TRO10032 LOWER THAMES CROSSING

COMMENTS ON APPLICANT’S SUBMISSIONS SINCE D4 For Deadline 5 (3rd October 2023)

SHORNE PARISH COUNCIL (IP ref 20035603)

Figure 1: The Medway river basin catchment in North East Kent, England

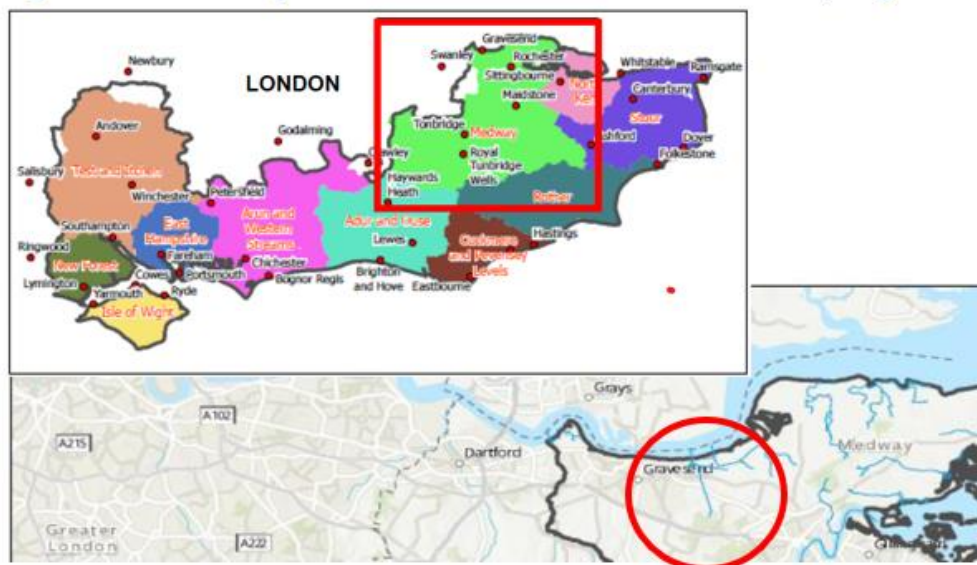
- We have queried many times as to the route taken by water in streams leaving the Country Park.
 - We note the following map from the Southern Water Drainage and Wastewater Management Plan (DWMP), Overview of the Medway River Basin Catchment, October 2022, Version 2. This again shows a watercourse leaving the Country Park and coursing north-west, so we again ask for the Applicant to contact Southern Water for clarification (and to report back).

- ExQ1 Q10.4.5 Site Information:
 - Thank you very much for asking this question in reference to Figure 14.1 - Surface Water Receptors and Resources [APP-322] as this is exactly the question that we have been asking repeatedly as discussed again above.

Plate 5.1 Main rivers within and near the Ramsar (Environment Agency, 2015)

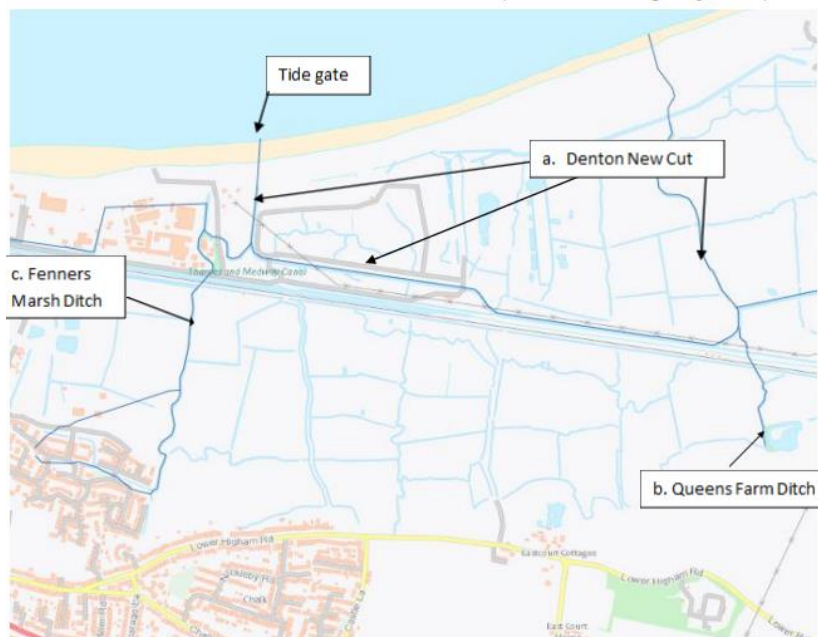
- ExQ1 Q10.6.3 Discharge to the River Thames:
 - While it is correct that the “Environment Agency is the drainage authority”, the North Kent Marshes Internal Drainage Board are responsible for ensuring/maintaining water levels in the interconnected marshes ecosystem.

- As we have evidenced previously elsewhere, the Great Clane Marsh area is prone to flooding and new built houses etc to the west are experiencing problems. Discharging additional water here is therefore a concern.
- The Applicant’s drawing on page 18 of ES Appendix 14.2: Water Features Survey Factual Report [APP-454] as below shows that there are more ditches involved than they show on their new drawing (Plate 2.5 on page 35 of REP4-193).
- There is another outflow to the Thames at the eastern part of Denton New Cut. Overall there is concern that the Applicant might cause potentially contaminated water to flow in a non-standard manner from west to east into the main part of the Ramsar Site.
